**CHANGE ORDER
NO. 1**

PROJECT TITLE: 0001 Chalk Bluff Road (CR203) Improvements Project

SUBJECT: CMO – 001 Addition of Mailbox Cluster and Pulloff
Laramie County – Chalk Bluff Road (CR 203)

P&P - 45

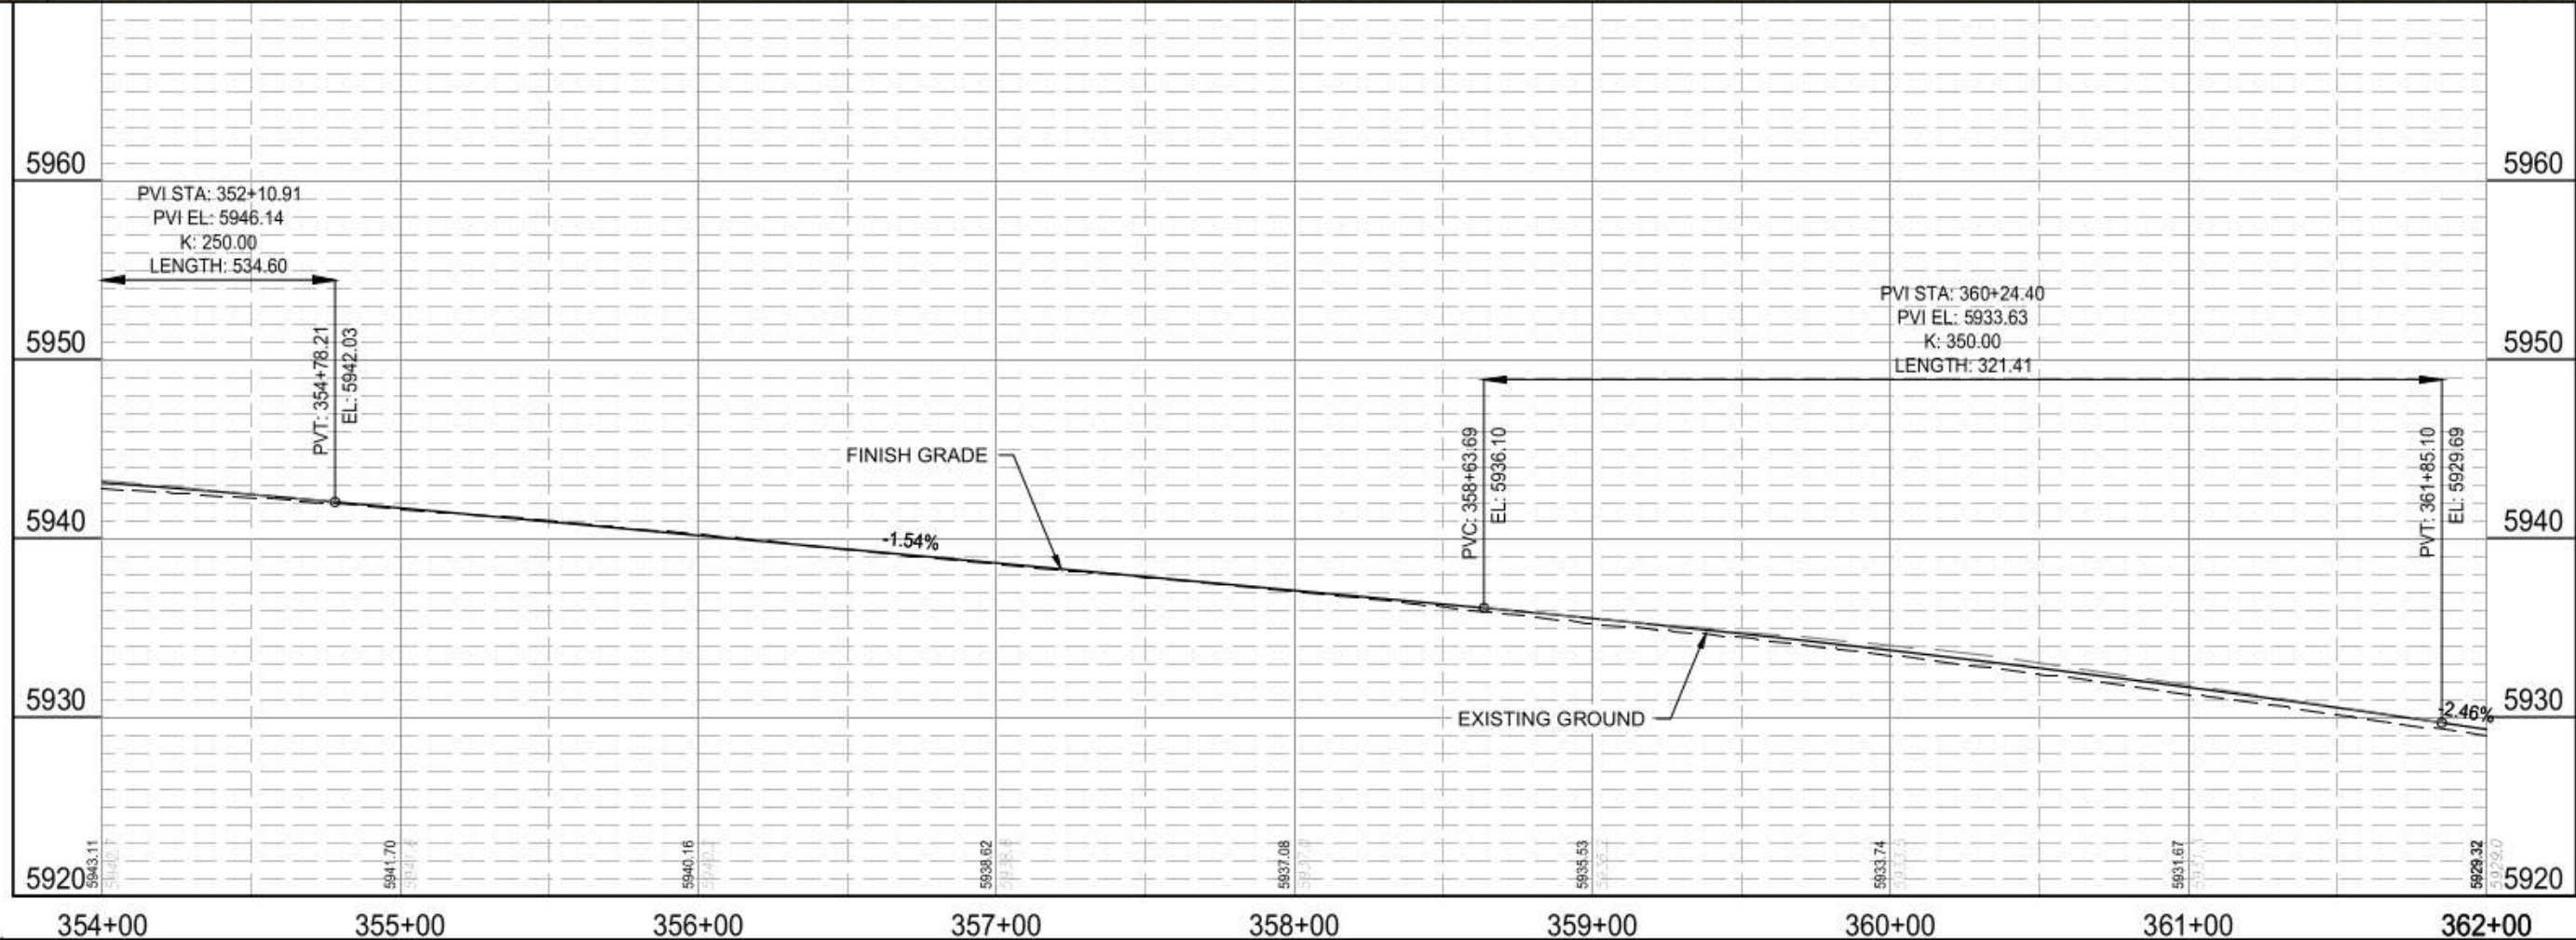
MAILBOX
CLUSTER
OPTION 2

PROPOSED CLUSTER
MB-1570-12 (12 TOTAL MAILBOXES W/1 PARCEL LOCKER)
PLM-1590-T2 (4 TOTAL PARCEL LOCKERS)

GRADING LIMITS
CATCH AT ROW

DWG NO. 57 OF 236

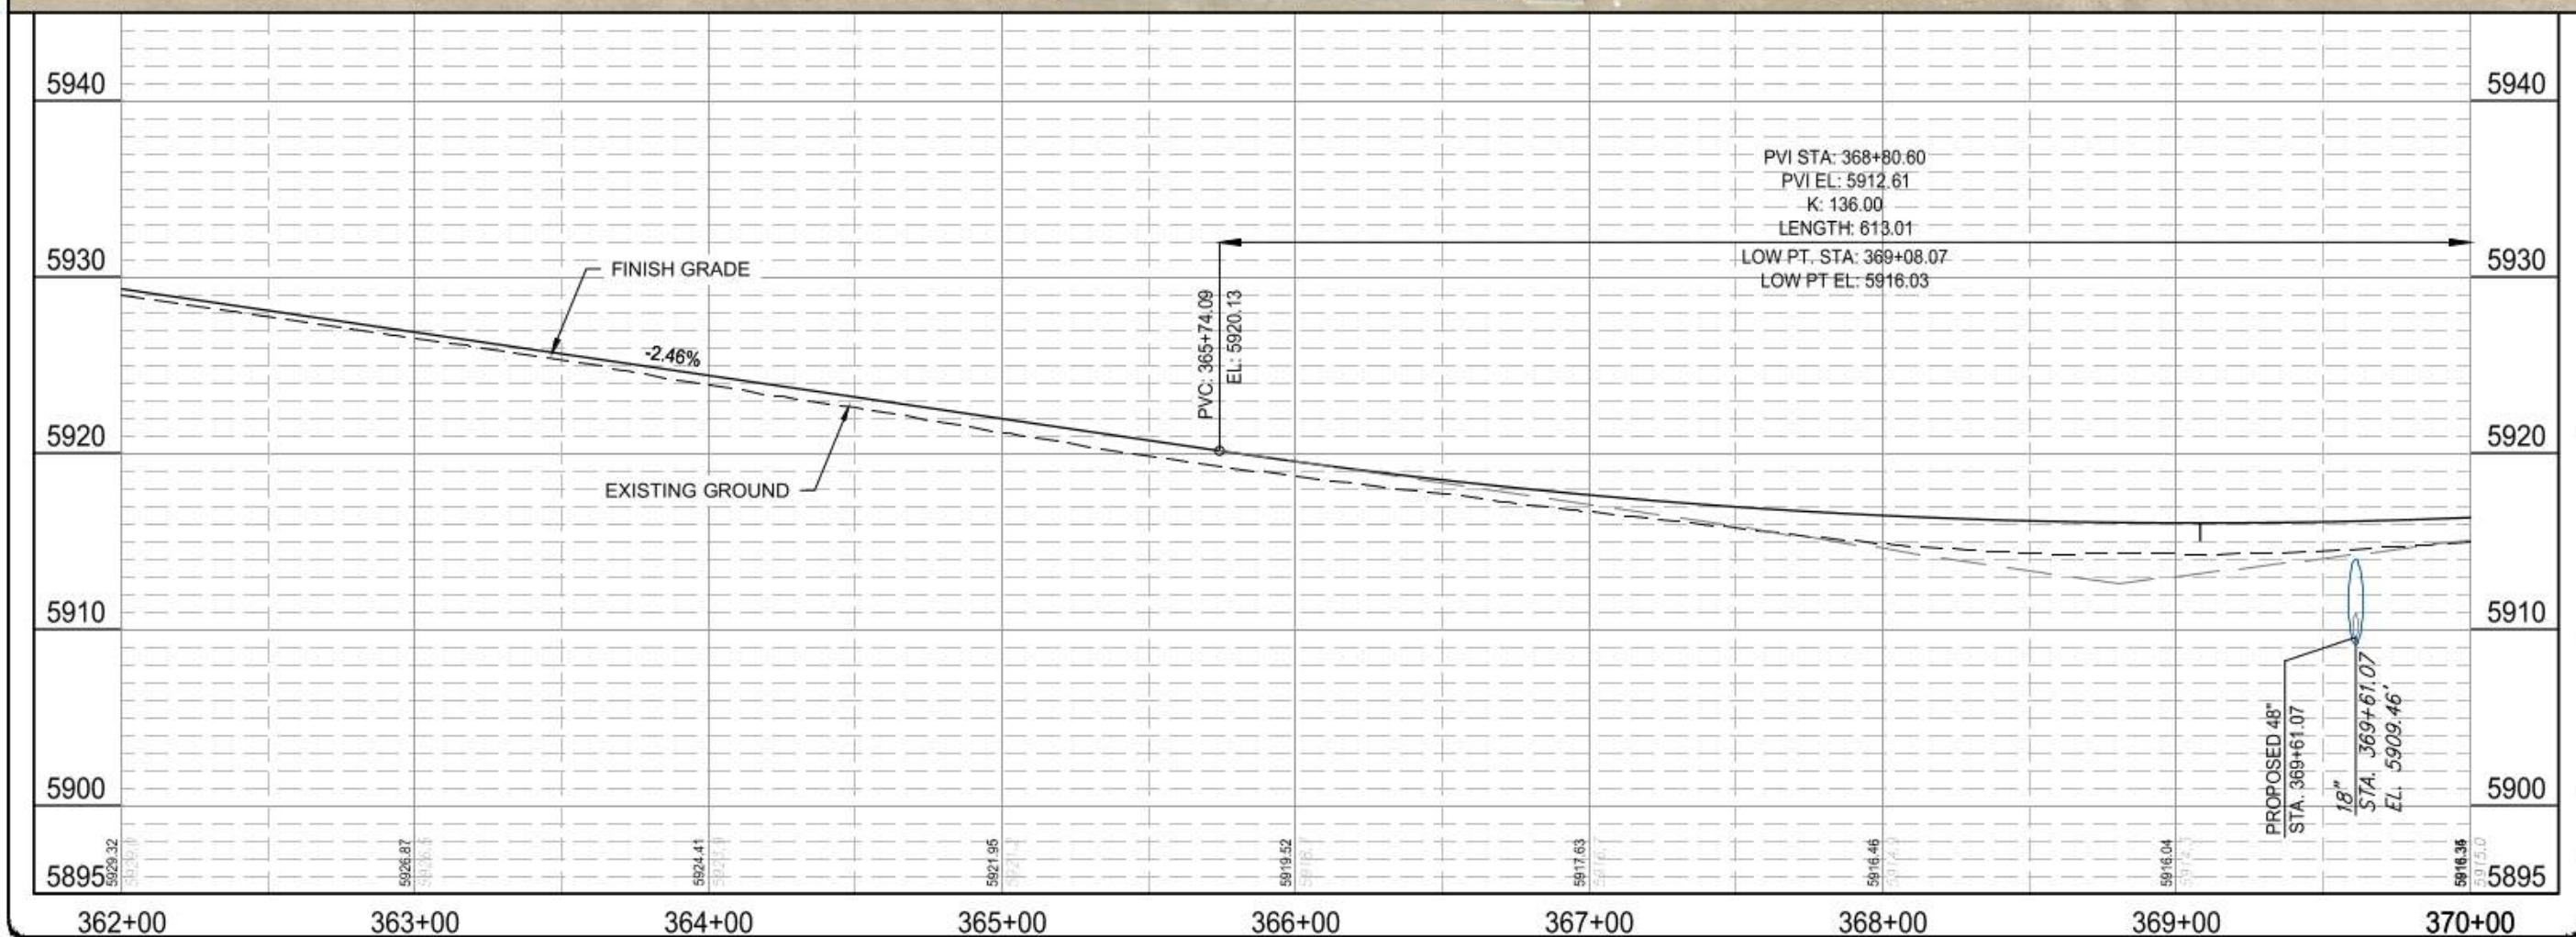
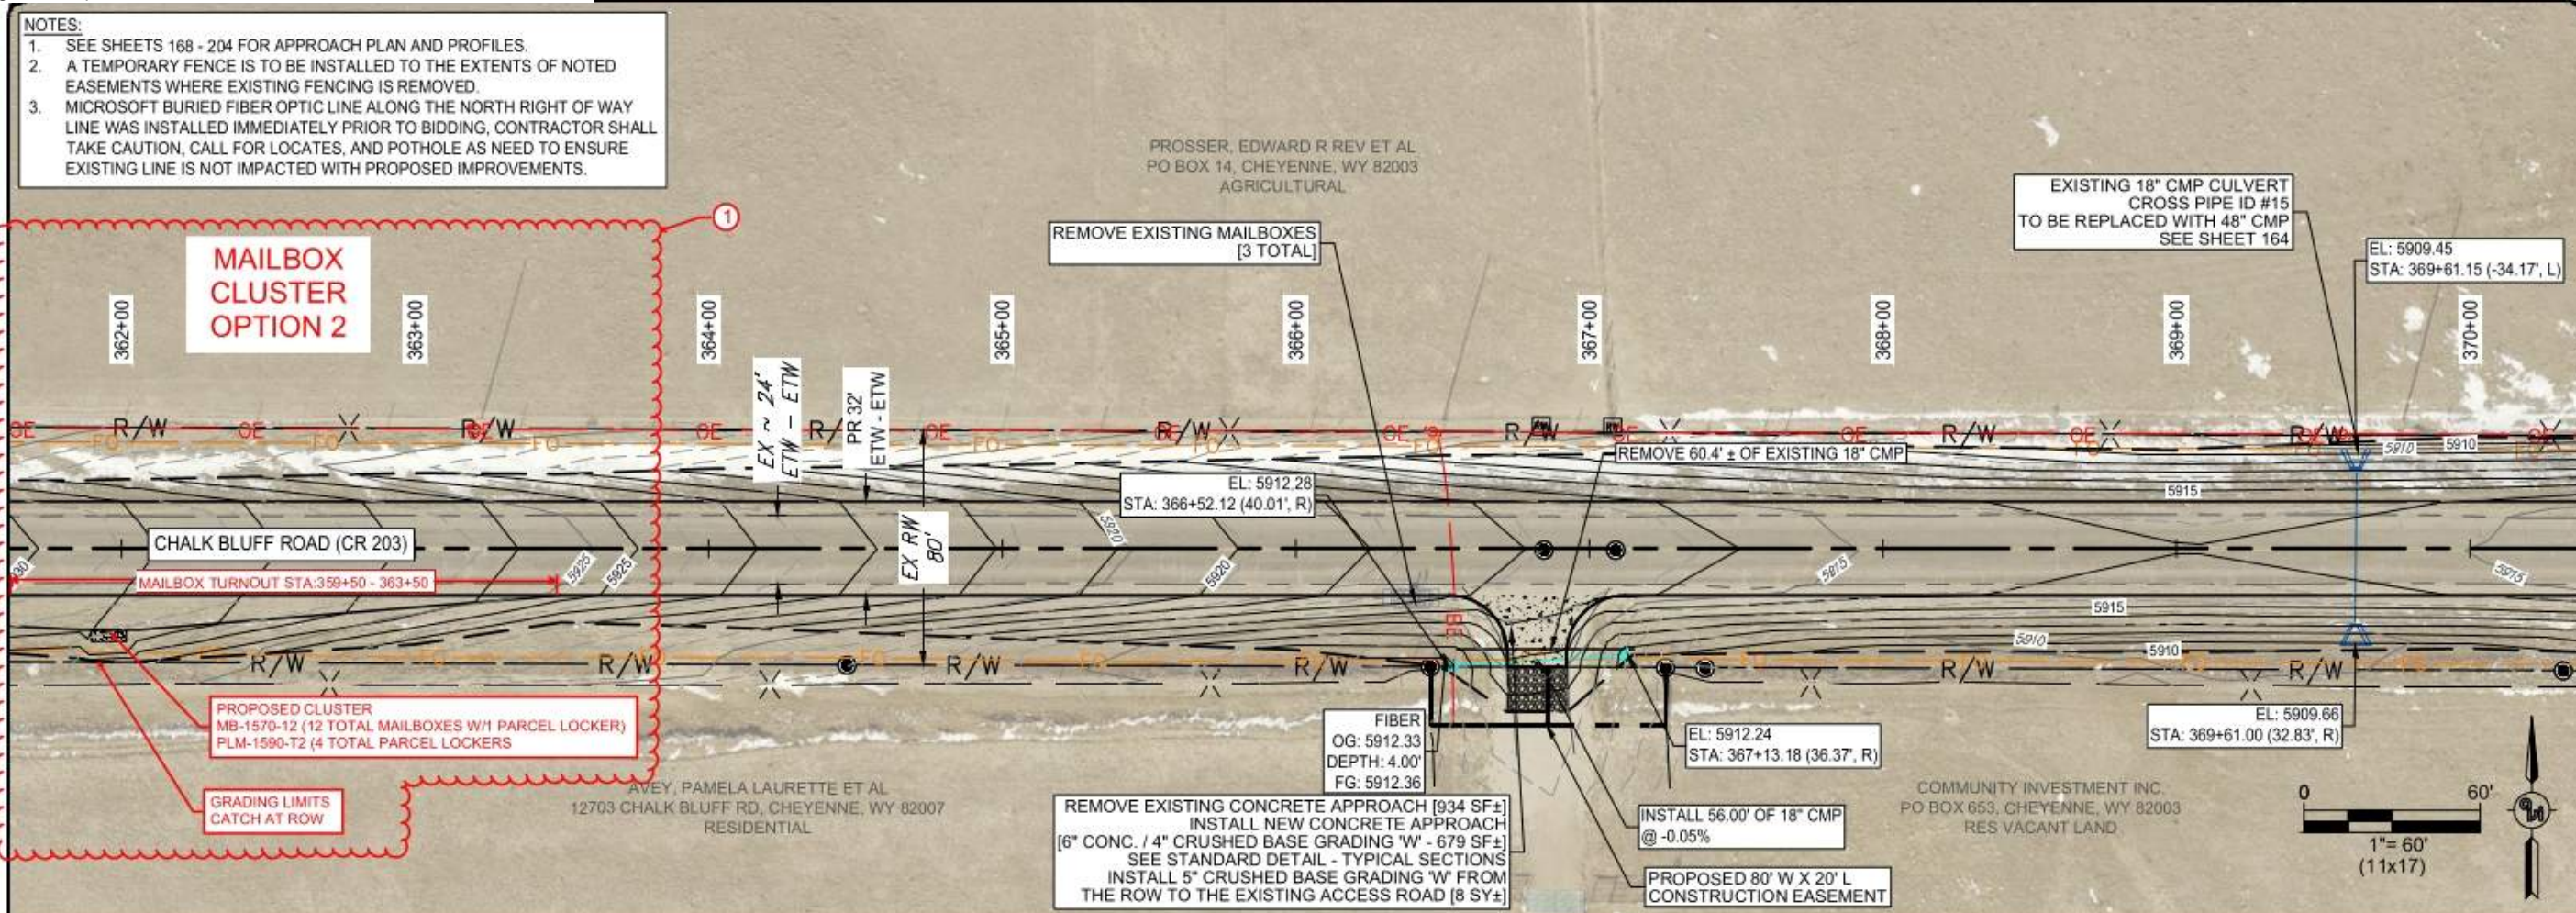
NO.	REVISION	DATE
1	MB CLUSTER 369+50 - 369+50	6/10/2026
